LOCKHEED AIRCRAFT CORP.		ENGINEERING STUDY <input type="checkbox"/>		CHANGE PROPOSAL <input checked="" type="checkbox"/>		LAC-98				
DATE 4-3-61		AFFECTS:		WSPO <input checked="" type="checkbox"/>		PROJECT <input checked="" type="checkbox"/>				
NAME OF MAJOR COMPONENT AIRPLANE		PART OR LOWEST SUBASSEMBLY FUEL PUMP		PART NO. & MODEL OR TYPE						
TITLE OF PROPOSAL : FUEL SYSTEM REVISION										
NATURE OF PROPOSAL : SEE PAGE 2										
REASON FOR PROPOSAL : 1. To improve reliability of the existing hydraulically driven fuel boost pump by replacing the present chip catcher with a 200 mesh strainer. 2. To reduce the possibility of engine flameout due to loss of fuel pressure particularly at high altitudes by providing an electrically driven fuel boost pump as backup for the existing hyd. driven pump. The new pump will be controlled by the pilot and is to be turned on for all operations above 50M ft.

NATURE OF PROPOSAL:

Change Proposal

FUEL SYSTEM DIAGRAM

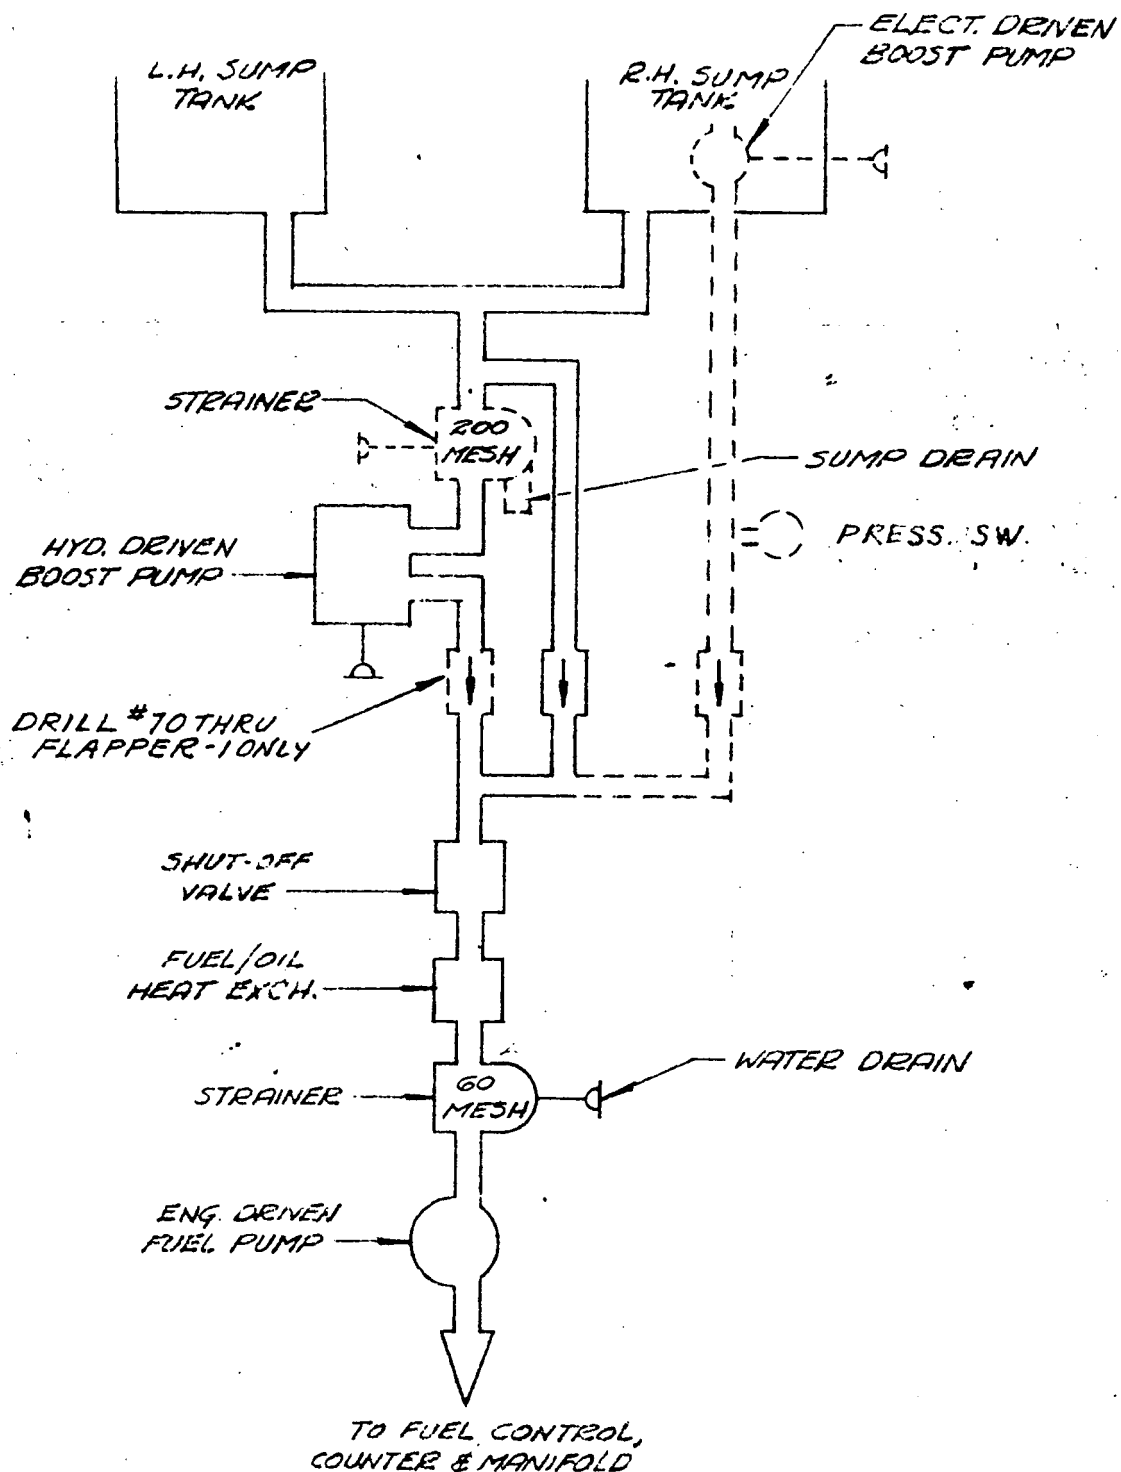
1. Modify the fuel system on all aircraft (except serials 342 & 358)* as follows:
 - a. Replace the existing Chip Catcher (P/N H-80) with a 200 mesh strainer.
 - b. Install a submerged A.C. electric motor driven boost pump in the right-hand sump tank. Install related plumbing to connect pump in parallel with the existing boost pump and bypass line. This includes the addition of two new check valves; one in each boost pump fuel out line, and a pressure switch between the check valve and the new pump (see attached diagram).
 - c. Replace the existing sump tank overflow light in the cockpit with a fuel pressure indicator light (elec. boost pump only) and install pilot's control switch. Install power relay on Q-bay "CB & Relay" panel and install system wiring.
 - d. On all aircraft remove the overflow float switch from the sump tanks.

SHOWING ADDED ELECTRICALLY DRIVEN
 SUBMERGED BOOST PUMP & 200 MESH STRAINER
